CLASS I SERVICE INSTRUCTIONS

No. 0608-159, Rev. I
ATA Code 73-20

SUBJECT: FLIGHT CONTROLS - ENGINE CONTROLS - INSPECTION AND/OR REPLACEMENT OF FUEL MIXTURE CONTROL AND CARBURETOR HEAT CONTROL

SYNOPSIS OF CHANGES: Serial effectivity of Part II is reduced and Part III is increased; warranty period is extended; man-hours for inspection is added and Part II inspection is clarified.

Figure 1. Control Quadrant Installation

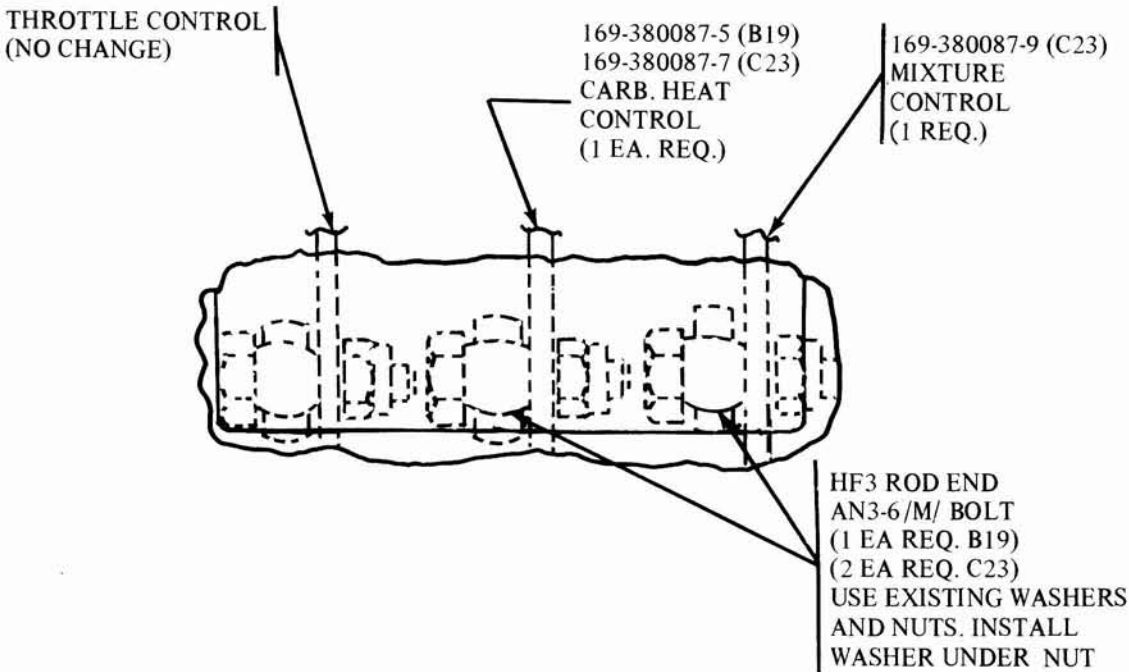
1. Visually inspect the end of the carburetor heat control by looking through the slots in the cover over the control quadrant. If the control is attached to the lever by a rod end, no further action is necessary. If the control is not attached with a rod end, proceed with the following steps.
2. Disconnect the carburetor heat control assembly from the quadrant lever. Discard the attaching bolt, but retain

7. Attach the control to the quadrant lever using the new AN3-6/M/ bolt and the existing nut and washer as shown in Figure 1.

14. Attach the controls to the quadrant levers using the new AN3-6/M/ bolts and the existing nut and washer as shown in Figure 1.

Figure 2. Mixture Control Routing

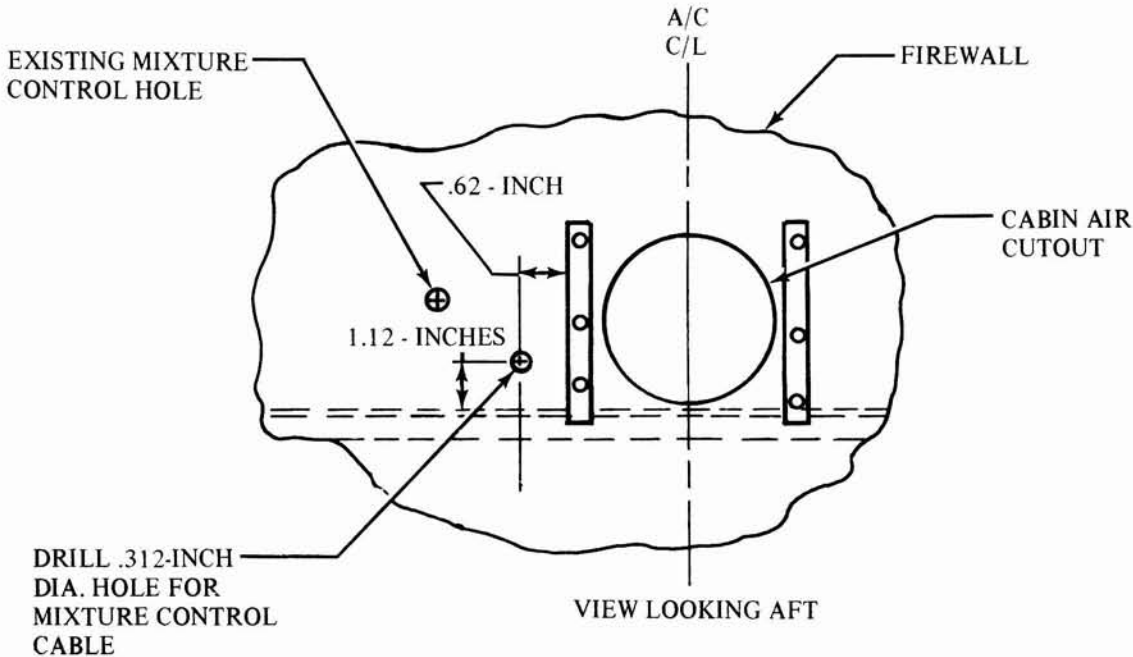
9. Drill a .312-inch diameter hole through the firewall as

shown in Figure 2.

4. Drill a .312-inch diameter hole through the firewall as shown in Figure 2.

Figure 3. Mixture Control Installation

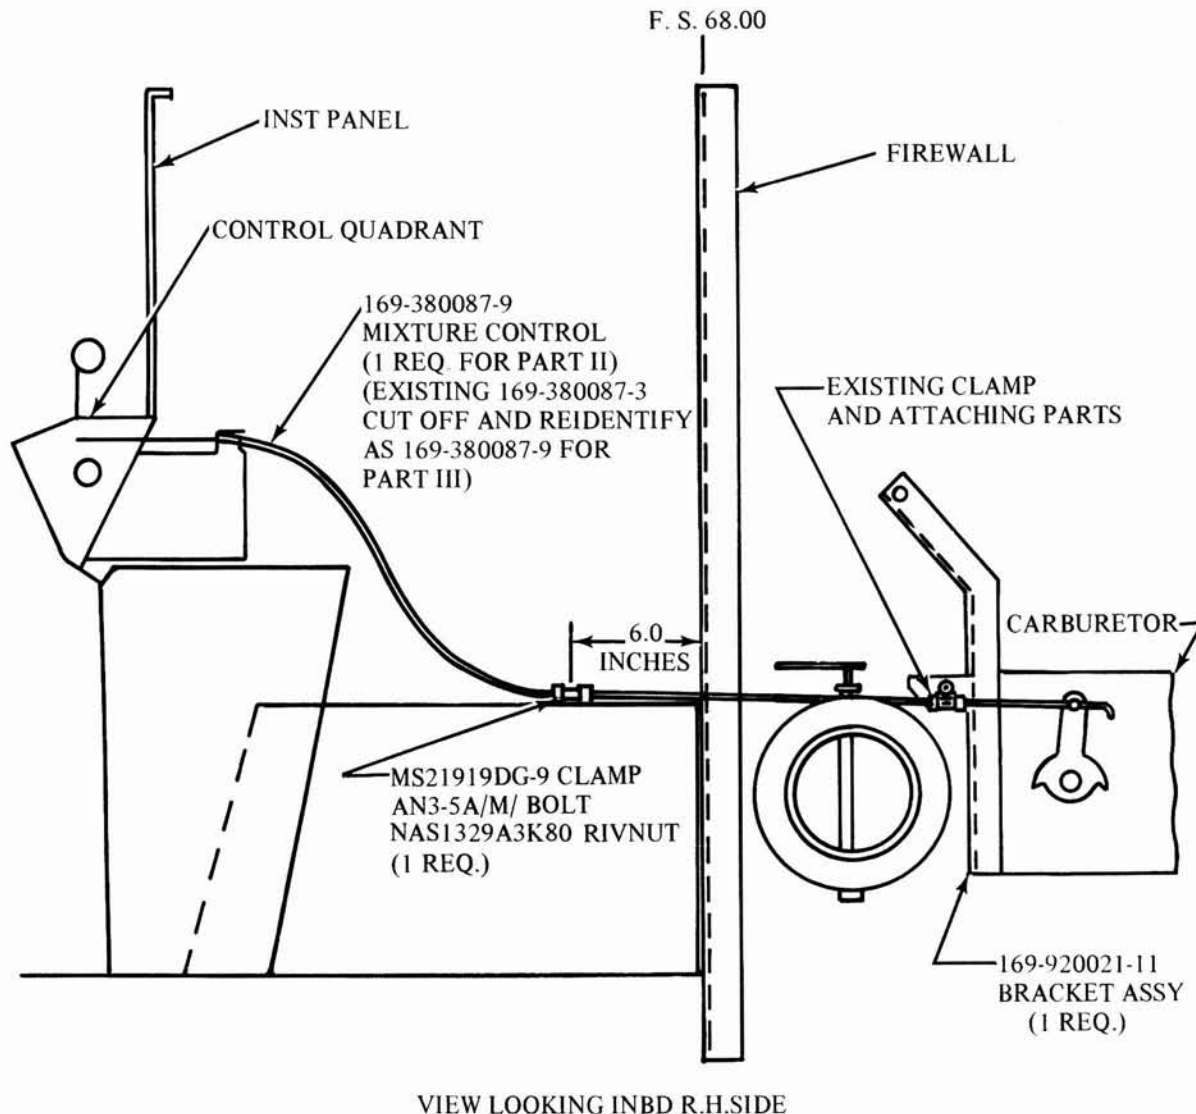
10. Attach the HF3 rod end to the quadrant end of the new P/N 169-380087-9 mixture control cable and route the cable through the hole which was drilled in the firewall in step 9. (See Figure 3.)

11. Secure the P/N 169-380087-9 control cable to the top of the control cover box with one each MS21919DG9 clamp, AN3-5A/M/ bolt and NAS1329A3K80 rivnut at a point six inches aft of the firewall. (See Figure 3.)

12. Remove the P/N 169-920021-1 bracket assembly from the carburetor and replace it with a new P/N 169-920021-11 bracket assembly. (Figure 3.)

5. Reroute the existing P/N 169-380087-3 mixture control cable through the hole which was drilled in the firewall in step 4. (See Figure 3.)

It will be necessary to shorten the 169-380087-3 control cable to adapt it to the new routing. After cutting off the cable, reidentify it as P/N 169-380087-9.

6. Secure the mixture control cable to the top of the control cover box with one each MS21919DG9 clamp, AN3-5A/M/ bolt and NAS1329A3K80 rivnut at a point six inches aft of the firewall. (See Figure 3.)

7. Remove the P/N 169-920021-1 bracket assembly from the carburetor and replace it with a new P/N 169-920021-11 bracket assembly. (See Figure 3.)

Figure 4. Fuel Mixture Control Extension Illustration

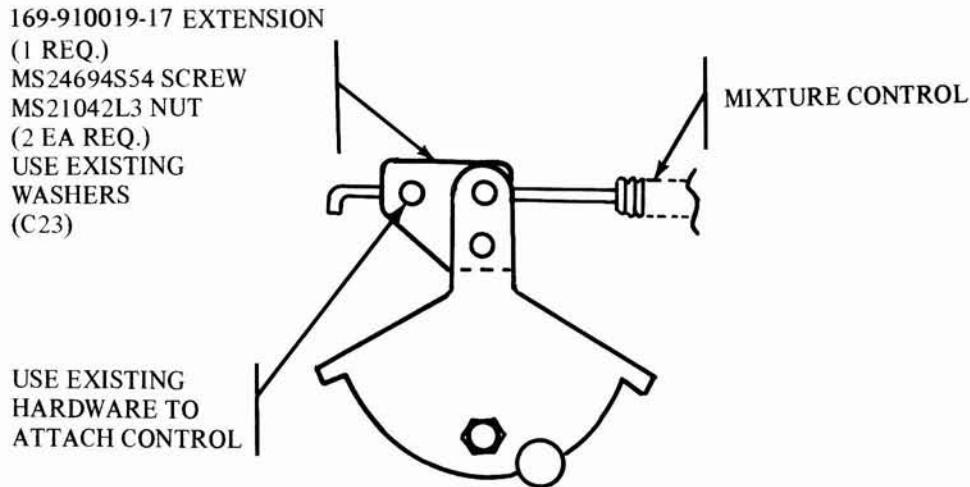
16. Install the new P/N 169-910019-17 extension on the carburetor idle cutoff cam using the new MS24694S54 screws, MS21042L3 nuts, and existing washers as shown in Figure 4.

9. Install the new P/N 169-910019-17 extension on the carburetor idle cut-off cam using the new MS24694S54 screws, MS21042L3 nuts and existing washers as shown in Figure 4.
